**AGENDA  
BOARD OF ADJUSTMENT  
REGULAR MEETING  
SEPTEMBER 21, 2022  
5:00 PM  
CITY HALL COMMISSION CHAMBERS  
204 ASH STREET  
FERNANDINA BEACH, FL 32034**

**BOARD OF ADJUSTMENT STAFF REPORT**  
**BOA 2022-0016**  
**SEPTEMBER 21, 2022**

| <b>Requested action:</b>          | Variance from LDC Sections 7.01.04(A)(7) & 7.01.04(C)(1) |

DATE: 5/16/22  
SCALE: 1"=30'  
DRAWING IS REDUCED IF LESS THAN 22" x 34"  
**GEOMETRY PLAN**  
North / Elev Key Sheet  
GE-1  
Page

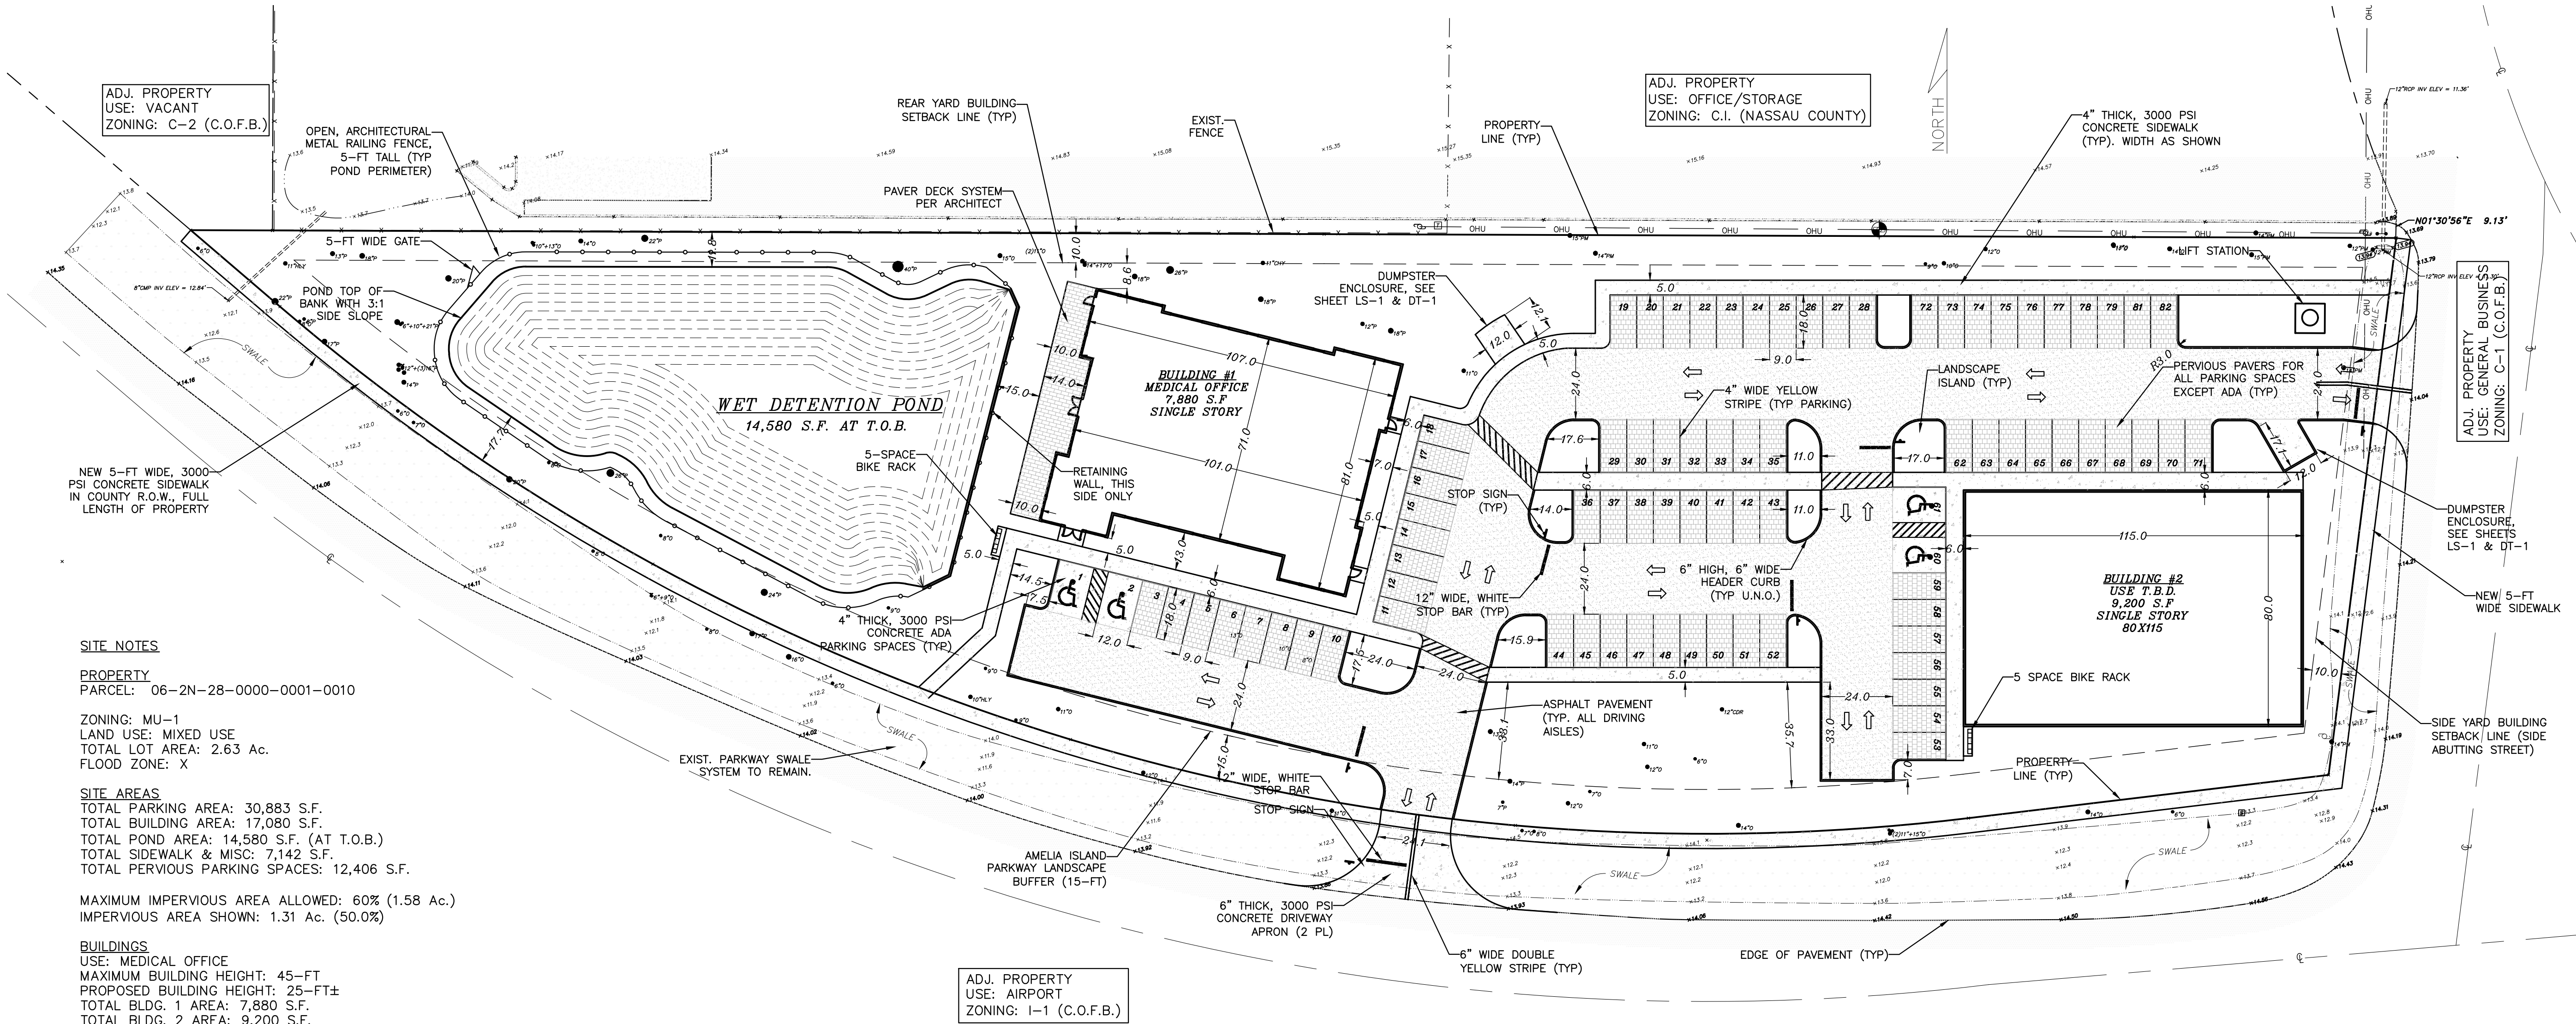
The applicant is requesting two variances from Land Development Code. The first requested variance is from LDC Section 7.01.04(A)(7) restricting parking spaces to no greater than 110% of the required minimum. The second variance request is from LDC Section 7.01.04(C)(1) which requires all new non-residential development to locate parking to the side or in the rear of the structures. A traffic study was not generated as part of the applicants request however, their letter of intent indicates a desire to consider the medical office needs through benefit of an alternative calculation which relies on the number of anticipated doctors, staff, and exam rooms instead of gross floor area.

The applicant's proposed gross floor area, for both uses, results in a maximum of 69 permissible spaces, including the 10% allowed overage. The applicant is requesting a total of 82 parking spaces. Additionally, LDC Section 7.01.04(C)(1) requires all parking to be located on the side or to the rear of the structures. The applicant seeks to deviate from this standard to allow approximately 20% of the parking stalls in front of the proposed structures.

TOTAL SPACES SHOWN: 82  
ADA SPACES: 4  
- NOTE: SITE IS OVERPARKED; VARIANCE REQUIRED FOR SEVEN (7) ADD'L SPACES.

Staff finds that the requested action, as presented, DOES NOT meet all six criteria for granting a variance, therefore staff must recommend DENIAL, but offers the following three considerations as a condition should the board seek to grant the requested variances:

1. The applicant must achieve at least 42% total lot area landscaping with a planting emphasis along Amelia Island Parkway.
2. The applicant must incorporate a vertical berm or landscape wall, measuring at least two feet high, within the landscape buffer fronting Amelia Island Parkway.
3. Buildings must provide architectural features consistent with LDC Section 6.04.00(L)(1). On building #2, a prominent architectural feature be designed to serve as a gateway feature at the corner of Amelia Island Parkway and Amelia Road and that greater detail in architectural features be included along its southern and eastern elevations.

LANDSCAPE PLAN  
SCALE: 1:30

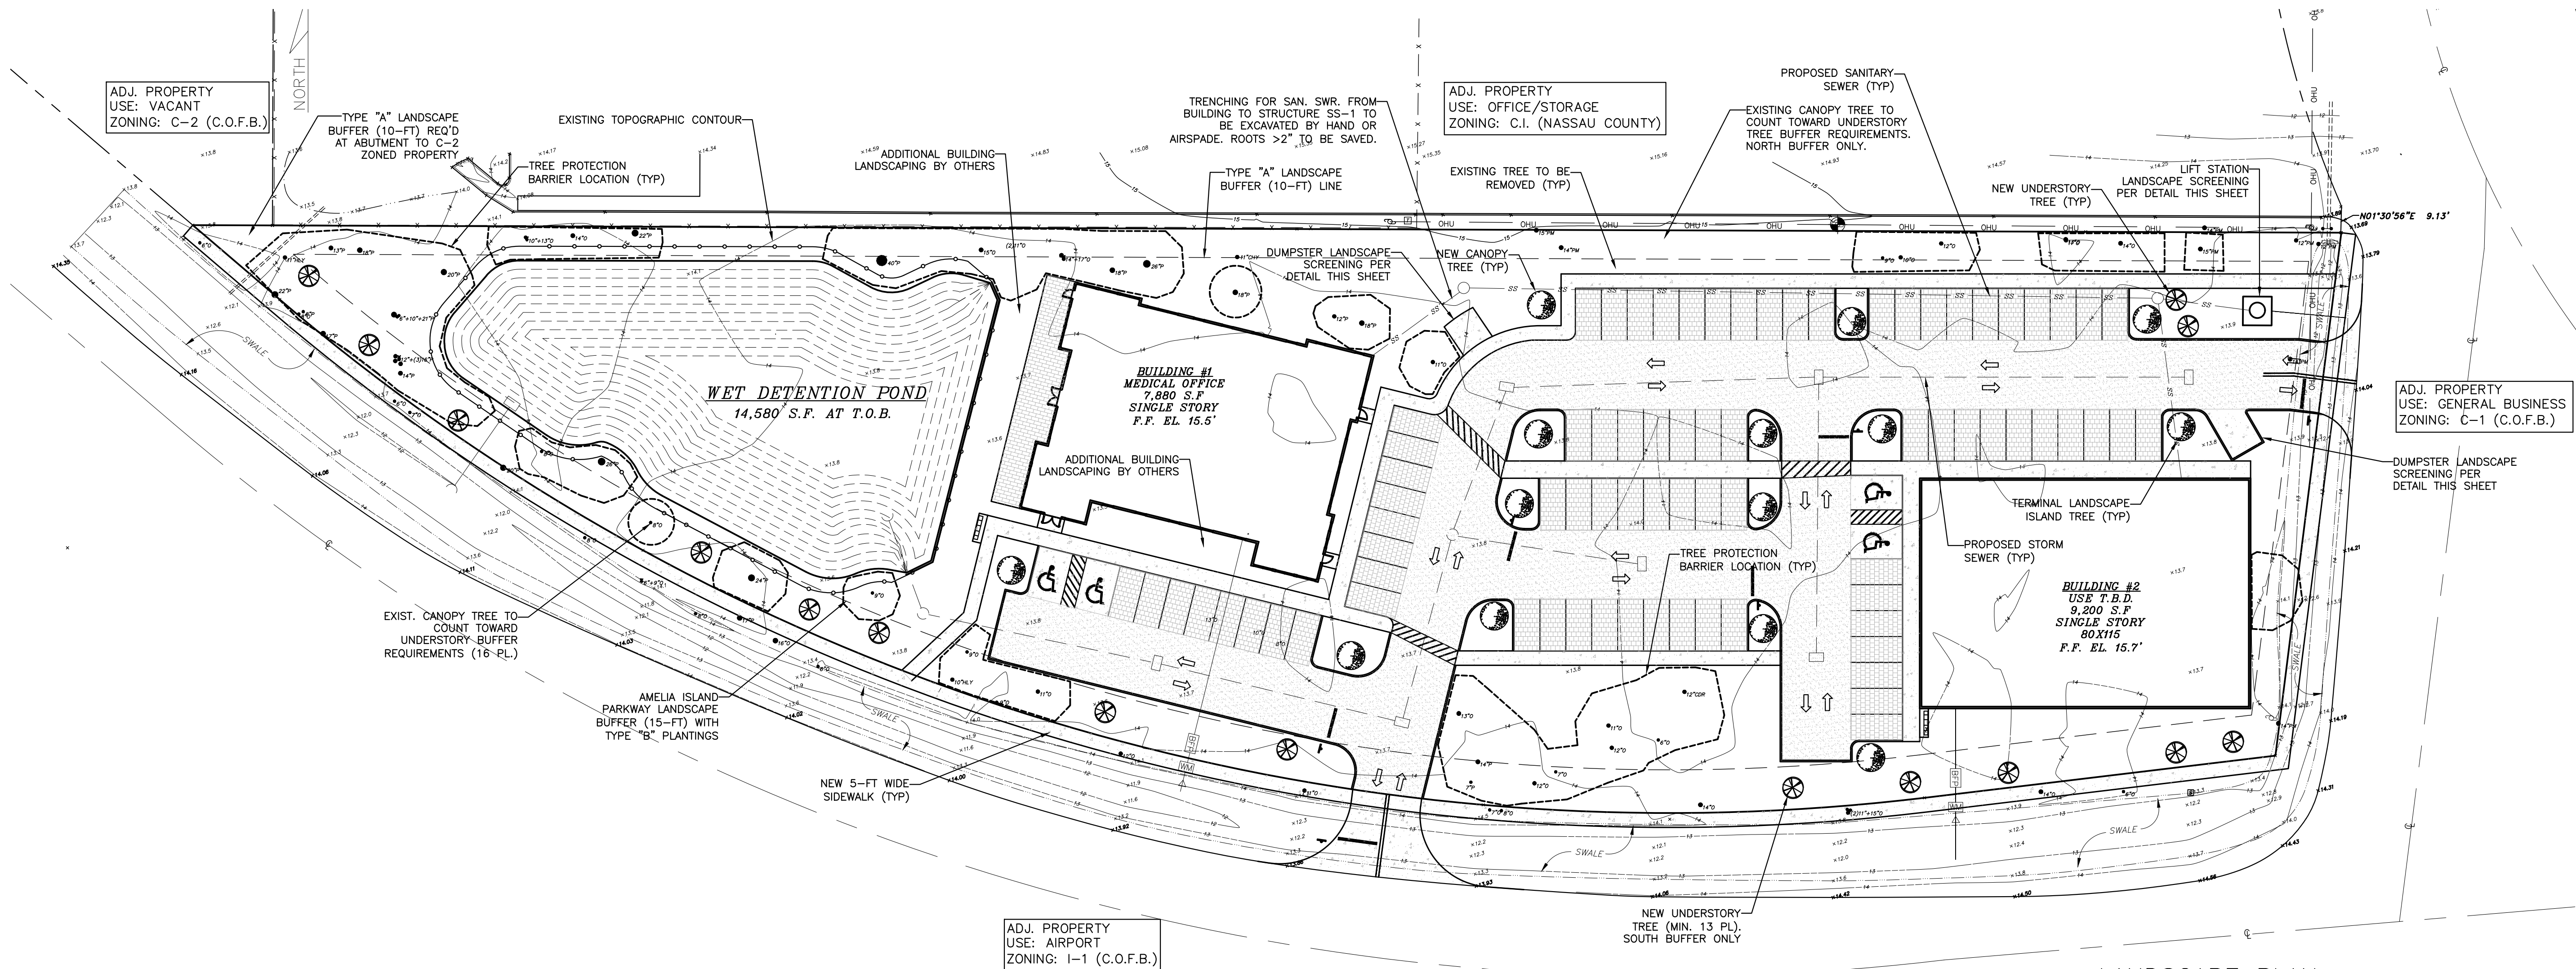
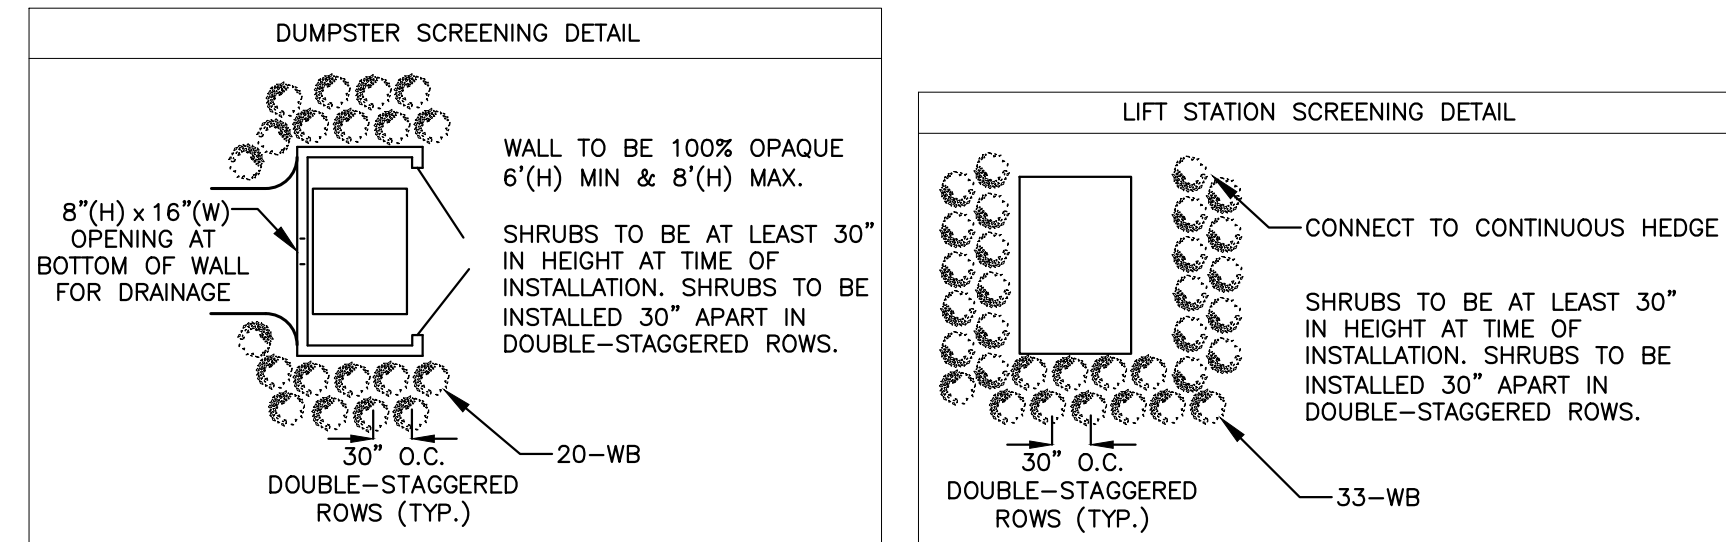
The applicant has offered an offset to their requested variances by more than doubling the required landscaping directed by LDC Section 4.05.06. Non-residential development is required to provide a at least 20% landscaped area. Although, a formal landscape plan has not been furnished at this time, the proposed site plan depicts 42% of the lot area will be landscaped. As demonstrated the applicant is working toward meeting the City's desired goal of masking parking and reducing an auto dominated focus with new commercial development. It is anticipated that the landscape plan will be reviewed for technical compliance as part of the Technical Review Committee issuance of a Local Development Order.

Staff offers that additional measures to support vertical layering of landscape materials such as a low-grade berm or retaining walls be considered in the landscape design to offer further masking of required parking from the Amelia Island Parkway frontage. Additionally, given that the proposed project is exclusively commercial in its expected use and its total square footage equals is over 17,000, staff requests board direction to require the City's commercial design standards contained in LDC Section 6.04.01 be a condition of approval should the board wish to grant the variance. Incorporation of these standards as a condition of approval, introduces minimum architectural design features for structures located along a highly visible corridor of the City.
